# Access Compliance Report

## Public Rights-of-Way

### (Curb Ramps)

Intersection ID: 50730	Main Street: BANTEER_RD	Cross Street: ALDERGROVE_RD	Location: SW
ADA ID: 982EDED7A207	Ramp Type: PerpDiag	Initial Pass/Fail: Fail	Overall Compliance: No
Severity Score: 8.75			
Codes/Mitigation Info/Possible Solution		Field Measurements/Component Compliance

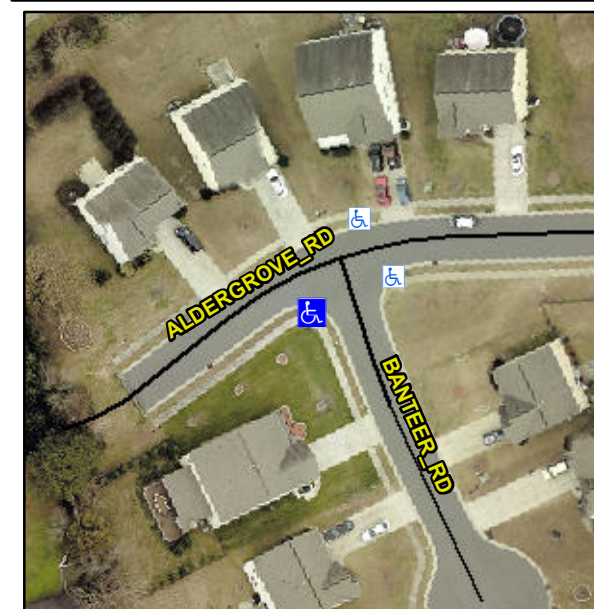
**Remove & Replace Curb Ramp With Two New Directional Ramps or Equivalent.**

**Not Found, R304.5.1**

Compliance	Description	Data	Compliance	Description	Data
N/A	Ramp Length (in)	47.5	Yes	Ramp Slope (%)	6.3
No	Ramp Width (in)	47.5	Yes	Ramp XSlope (%)	0.4
N/A	Flare Type LT	N/A	N/A	Flare Type RT	N/A
N/A	Flare Slope LT (%)	N/A	N/A	Flare Slope RT (%)	N/A
N/A	Flare Traversable LT?	N/A	N/A	Flare Traversable RT?	N/A
N/A	Landing Length (in)	N/A	N/A	DWS Provided?	N/A
N/A	Landing Width (in)	N/A	N/A	DWS Contrast?	N/A
N/A	Landing Slope (%)	N/A	N/A	DWS Length (in)	N/A
N/A	Landing X Slope (%)	N/A	N/A	DWS Full Width?	N/A
N/A	Landing Curb? (Y/N)	N/A	N/A	DWS Offset (in)	N/A
N/A	Shared Landing?	N/A			
N/A	Gutter Ponding?	N/A	N/A	Gutter Slope (%)	N/A
N/A	Gutter Lip Ht (in)	N/A	N/A	Gutter X Slope (%)	N/A
N/A	Painted X Walk1?	No	N/A	Painted X Walk2?	No
	X Walk 1 Direction	To E		X Walk 2 Direction	To N
N/A	X Walk 1 Width (in)	N/A	N/A	X Walk 2 Width (in)	N/A
	X Walk 1 Slope (%)	4.9		X Walk 2 Slope (%)	0.9
	X Walk 1 X Slope (%)	3.5		X Walk 2 X Slope (%)	4.5
